**Ref: SSD-78996460**

**RE: SUBMISSION TO SSD-78996460 16-24 LORD STREET & 21-27 ROSEVILLE AVENUE, ROSEVILLE**

<b>Attachment 1 - Ku-ring-gai Council's Response to Applicant's RTS</b>	
<b>Summary of Council's key comments from original submission</b>	<p><b>Objection remains unchanged</b></p> <p>Council notes the application has been amended, however Council's key contentions with the proposal remain unresolved. This includes:</p> <ol style="list-style-type: none"> <li>1) Inappropriate built form that is inconsistent with the desired future character of the locality.</li> <li>2) Built form does not appropriate respect the existing heritage conservation area.</li> <li>3) Demolition of contributory items within a heritage conservation area is inconsistent with Clause 5.10 of the KLEP 2015.</li> </ol> <p>It's noted that no additional developments can occur within this locality due to the gazette of the Ku-ring-Gai TOD amendment. Given this, if this development is to proceed (which Council does not support), then the development must be amended to further respond to the surrounding low-density character. Council seeks that DPHI require amendments to the proposal to ensure any developme

Figure 2: Extract from KDCP 2015 demonstrating how buildings are to be designed interfacing a heritage Item (Source: Part 19 – KDCP Heritage Items and Heritage Conservation Areas)

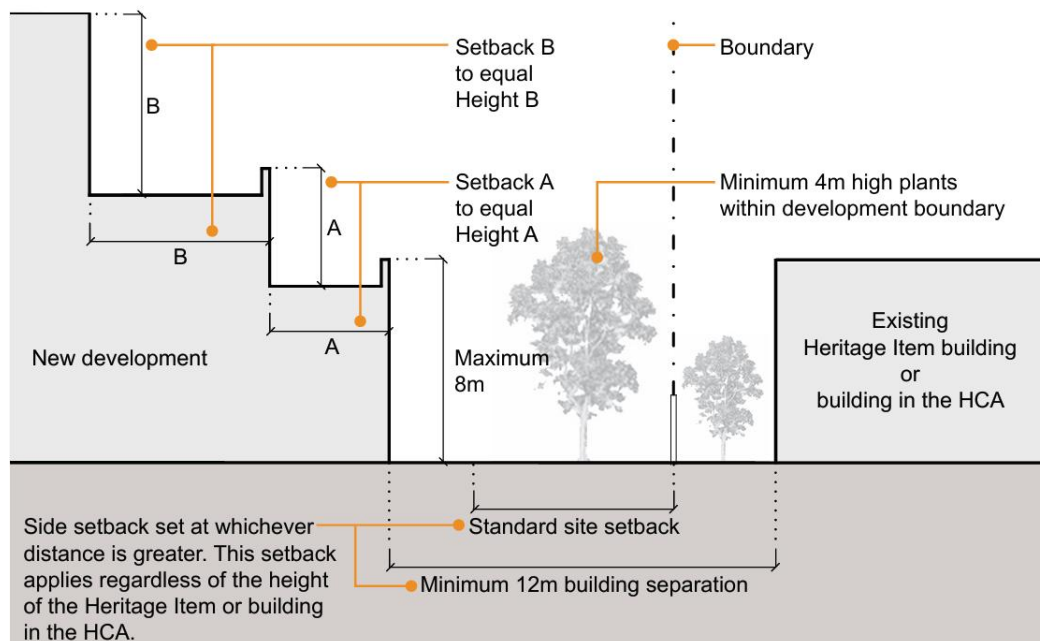
- Any 3 storey element interfacing the Scout Hall is to be setback a minimum 12m per Council's DCP Section 19F.2 Building Setbacks, Control 4. (Figure 2).
  - Council notes that DPHI required this in the assessment and determination of SSD-78775458.

Figure 3: Mark up of Section B (Base Source: FK Australia)

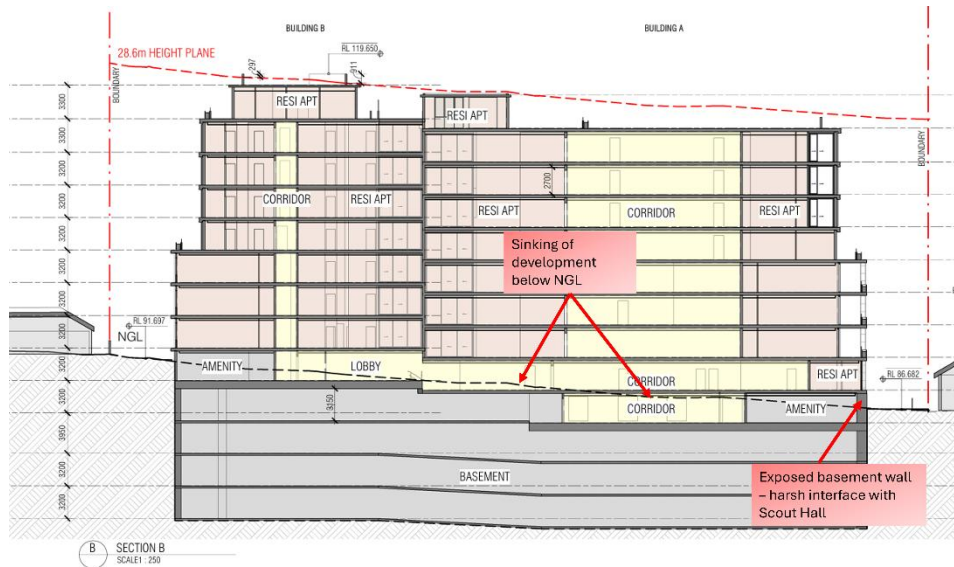
<p><b>5 Building Height</b></p>	
<p>The developments HoB was difficult to confirm due to missing information.</p>	<p><b>Matter Resolved</b></p> <p>It's noted that the applicant has reduced the overall building height reducing the buildings height exceedance at its worst to 1.07m. The applicant has also updated its plans with levels from the survey to confirm the point of which height of building is measured.</p>
<p>Clause 4.6 request is not well founded.</p>	<p><b>Matter for DPHI to be satisfied off.</b></p> <p>Council maintains that there are insufficient environmental planning grounds to justify the breach of the development standard. The developments height breach is exacerbated by the developments non-compliance with key development controls such as setbacks, built upon area and heritage controls.</p> <p>The cumulative effect of not complying with numerous planning controls indicated that there are insufficient environmental planning grounds to justify that exceedance to HOB is unreasonable and unnecessary.</p> <p>As noted below, whilst there remains a height breach, this height breach is not well-founded as the applicant bulk and scale has not been reduced. This is a result of the applicant sinking the built form underground, rather than making any meaningful positive reductions to building height. As such it results in built form that remains uncharacteristic of the area and ad's additional environmental impacts through excessive excavation and uncharacteristic elements (exposed basement walls and additional retaining walls) now introduced into the HCA.</p> <p><u>Additional Comment</u></p> <p>Upon review of the applicants revised plans whilst the HoB has technically decreased in accordance with the definition under the standard instrument, this height reduction <b>is technical only</b>. The applicant has effectively sunk the entire building below ground to reduce height, rather than make meaningful height reductions.</p> <p>Council is concerned with the excessing additional excavation now associated with the development, including the sinking of the majority of the ground floor under ground. This design move is inconsistent with the low-density character and results in additional impacts such as:</p> <ul style="list-style-type: none"> <li>• Exposed basement walls (1.9m in height) which are incompatible with the surrounding environment and create a harsh interface with the adjoining heritage item, detracting from its significance.</li> <li>• Excessive excavation results in more retaining wall structures interfacing the public domain, that are destructive to the local character.</li> <li>• Amenity of occupants is reduced as residential lobbies are sunk below ground.</li> <li>• Additional impacts on trees now results from the building being sunk.</li> </ul>

At human scale, the Applicants design move of sinking the building does not assist in any perceivable reduction to bulk and scale. Council recommends that DPHI seek the applicant revise their design to remove exposed basement walls, and make meaningful amendments to their building height, that don't involve sinking the development further underground.

Figure 5: Mark up of Lord Street elevation (Base Source: FK Australia)

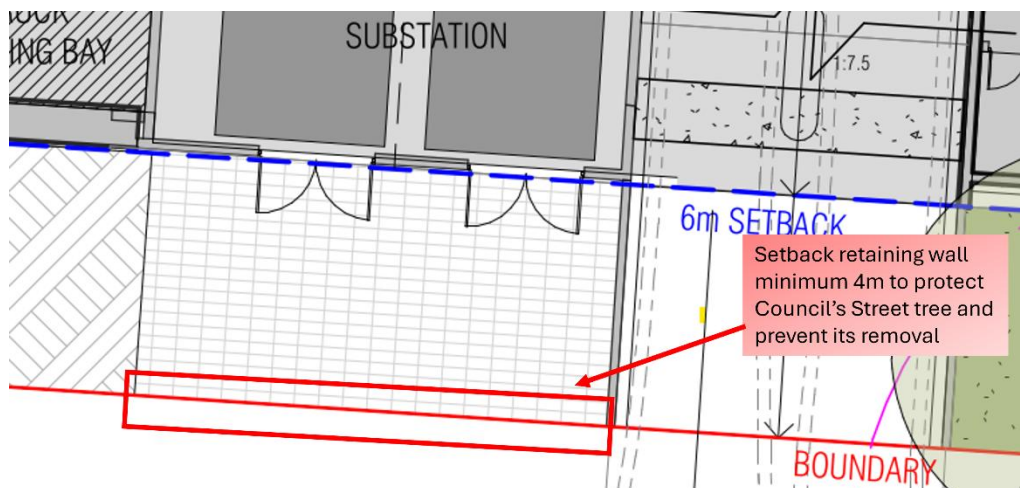
c) Objective 4O-2 Landscape design contributes to the streetscape and amenity	<p><b>Matter Not Resolved.</b></p> <p>Council's EIS position on this matter remains outstanding that requires further revision by the applicant. Council's recommendations on these items are below:</p> <p>I. <b>Unresolved.</b> small trees are still shown within the front setback along Roseville Ave.</p> <p><b><u>Design changes recommended</u></b></p> <p>Council recommends the following reasonable changes are considered to enable tall trees to be located within the front 6m setbacks to meet this ADG 4O-2 objective.</p> <ul style="list-style-type: none"> <li>• Relocate the proposed trees 5m from the façade to create a useable POS area.</li> <li>• Change the (LAG ind) <i>Lagerstroemia indica</i> (Crepe Myrtle) small tree to a medium-sized species such as <i>Nyssa sylvatica</i> (Sour-gum), <i>Alloxylon flammeum</i> (Tree Waratah), and/or <i>Corymbia eximia</i> (Yellow Bloodwood) to soften the built form and adequately contribute to the streetscape and amenity.</li> </ul> <p>II. <b>Unresolved</b> – The extent of paving adjacent to the subterranean substation and vehicular cross over has not been modified. The extent of paving is considered excessive at 20m wide. Access to the subterranean substation is unclear. The plans are not coordinated, and the landscaping is showing planting in front of one of the substation doors. In addition, the 6m wide excavation, up to a depth of 3.4m to the boundary line, adjacent to the</p>

subterranean substation(s) is considered unacceptable and excessive. This is a poor landscape outcome to a prominent street frontage. This level of excavation and depth is uncharacteristic of the HCA and must be amended (Figure 6).

The extent of excavation and paving should be halved in front of the substation and landscaping shown to soften the façade in line with the **ADG objective 40-2**.

The retaining wall is to be setback a minimum 4m (Figure 5) from the boundary line, whilst still enabling access to the substations from the Lord St frontage. Refer to comments to regarding the unapproved removal of Councils Street tree T20 shown to be removed due to these proposed works below.

Figure 7: Extract showing recommended design change (Base Source: FK Australia)

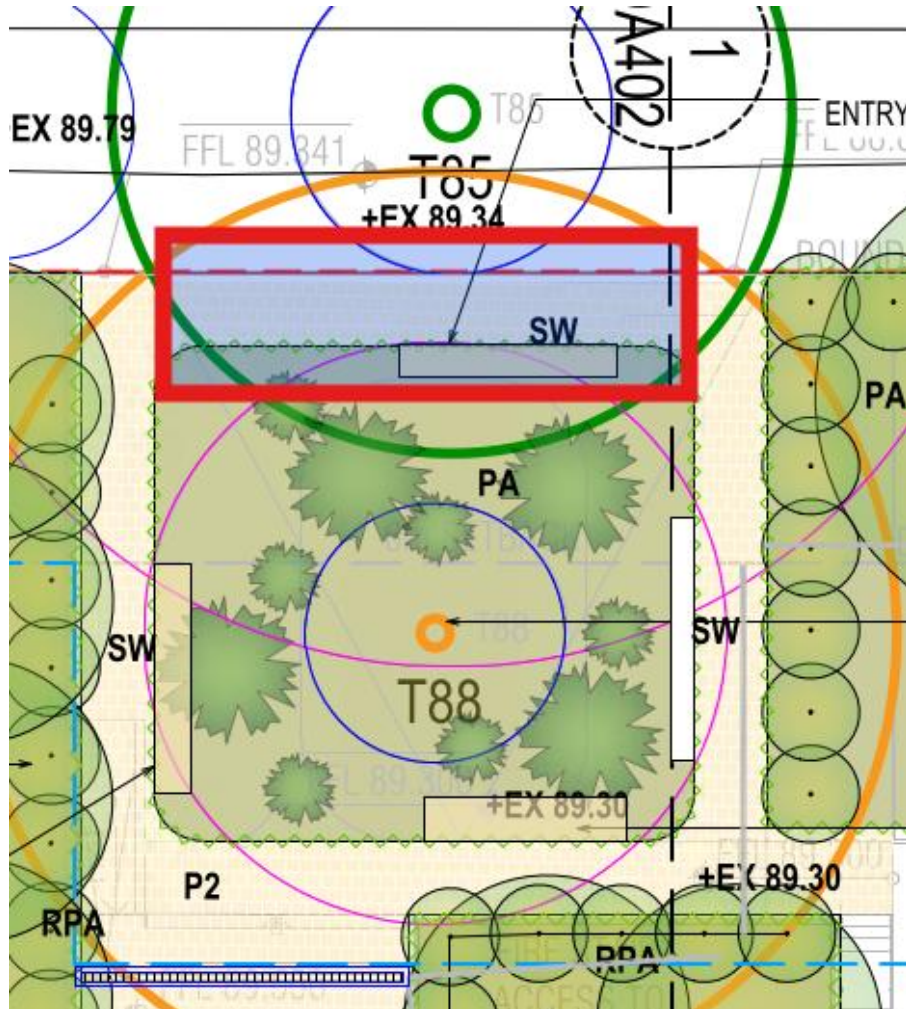
**Unresolved** - superfluous path shown along the boundary edge between trees T85 and T88 will have an encroachment of 19% which should be reduced to make this feature tree viable for the long-term.

As per the above comments to T85, Council recommends minor landscape design changes are made to drastically reduce the level of encroachment to a minor level (less than 10%) such as the following - remove the superfluous path and seat facing north, (between trees T85 and T88) and replace with soft

landscaping (Figure 7). This will enable the root zones between these trees to be contiguous, creating a large, viable deep soil area and avoid severing or damaging any roots unnecessarily.

Figure 8: Extract of survey plan with levels highlighted around tree T93

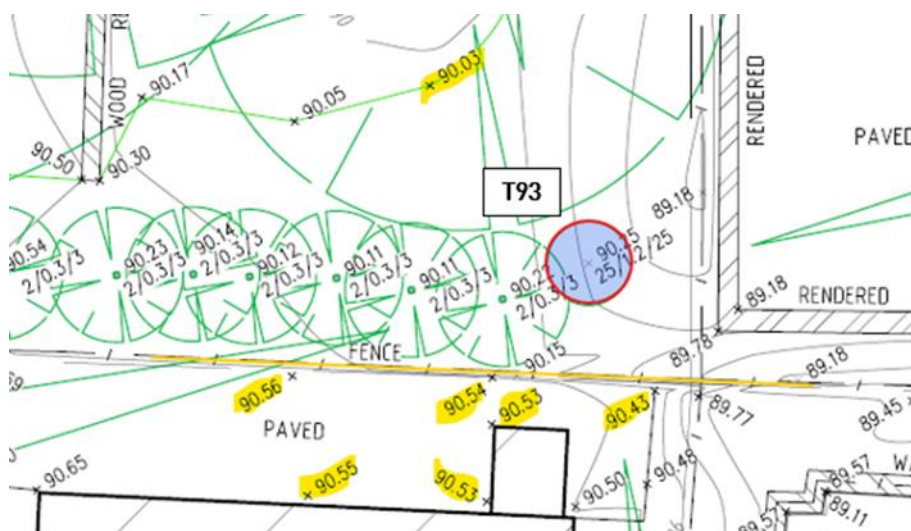
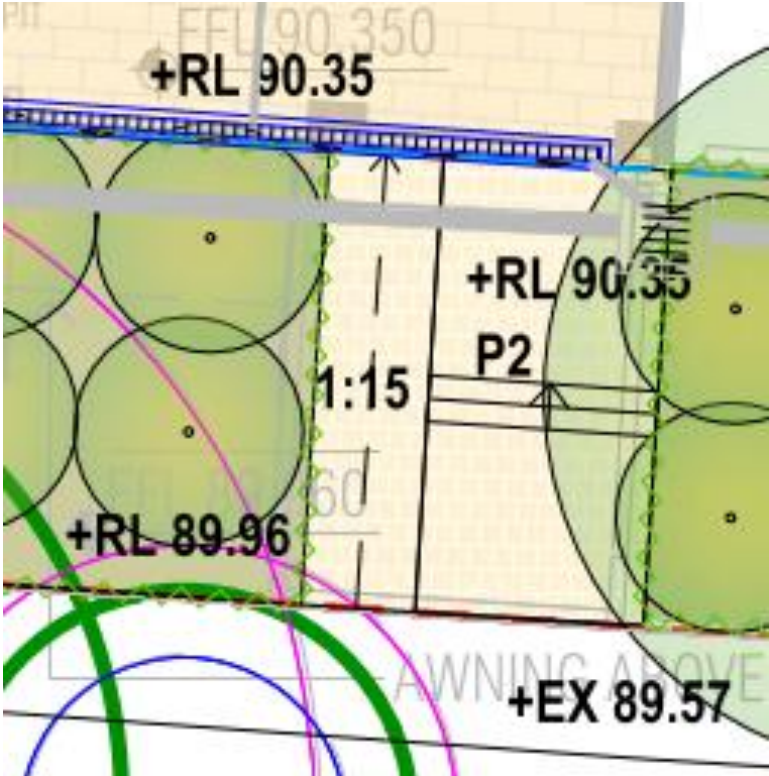
The landscape plans have not been sufficiently amended to reduce the level of encroachment into the notional root zone (NRZ) to an acceptable level. The Arborist Report states it has a ‘major’ encroachment (21% NRZ) as per the AS4970-2025 protection of trees on development sites. However, the Arborist Report failed to consider the fact the levels are higher on the southern side by 250-650mm (Figure 8) and the surrounding deck finish level has been set from the lower northern side of the tree.

This means that the level of encroachment **exceeds 50%**, not 21%, due to the required ground excavation on the southern side to enable the deck to be built level and “above the natural grade”. This will be detrimental to the stability of the tree, which is a great risk in this proposed high density, residential area. In addition to the decking, the landscape plans are showing seating underneath the tree, encouraging people to sit below this tree. The amount of root loss will ultimately lead to its decline and removal, which is not supported by Council.

- Removing the decking area to the south to retain the existing ground levels and/or stepping the decking up over the natural grade to avoid any unnecessary excavation and/or compaction into the natural ground on the southern side.
- Overall, it is recommended the decking and cumulative development encroachment should be reduced to less than 15% (preferably less than 10%) and the remaining NRZ maintained as soft landscape with no construction works.

Figure 10: Extract showing high boundary retaining walls (Source: FK Australia)

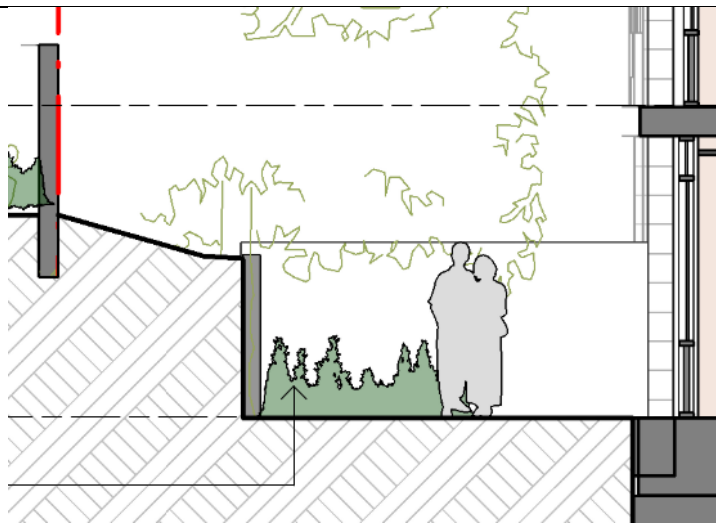
In addition, the western setback is now proposing level changes between 1.7m up to 3.3m requiring excessively high retaining walls. High solid walls are not supported by Council and are not in keeping with the character of Roseville HCA or the KDCP Part 21.1 landscape objectives.

**Council recommends plans** are amended to ensure all retaining walls are reduced to no greater than 900mm (preferably 600mm) to avoid the need for additional barriers and to reduce the landscape cut and fill as per the KDCP Part 21.1. Terraced walls are to be separated by a minimum 600mm planting bed to ensure there will be adequate soil to support the growth of planting in between the walls and to soften the retaining walls. Seating walls could be introduced to take up some of the level changes.

Figure 13: Left Image shows building interface with Heritage item, Right shows proposed (Source: FK Australia)

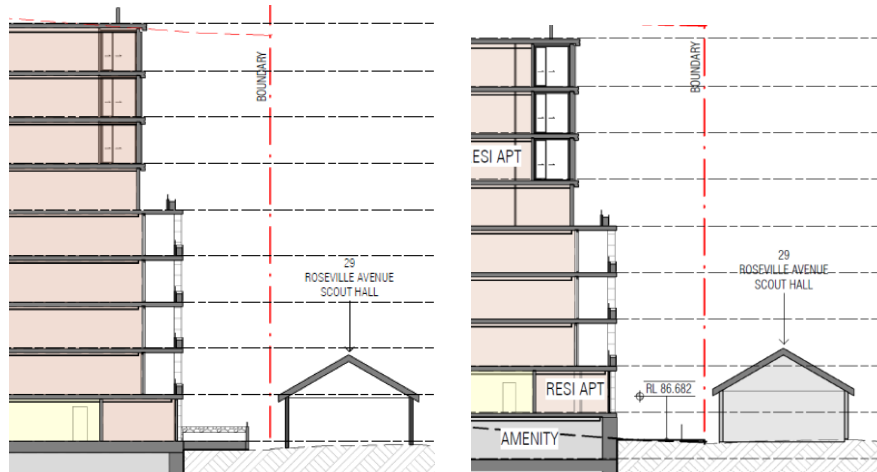
Whilst noting the applicant has made minor changes to the design as shown in Figure 13 and 14. These changes don't assist in reducing the bulk and scale of the development at the key interface with the adjoining heritage item.

The proposed setback from the Scout Hall will be less than 12m from a 4 storey high sheer wall. The proposed setback from the stone building will be just over 12m to a revised 4 storey high sheer wall.

The proposed revised 4 storey podium wall will have the appearance of a rectilinear sheer high wall which is notably different in scale and contrast to the single storey heritage buildings and creates a severe visual impact.
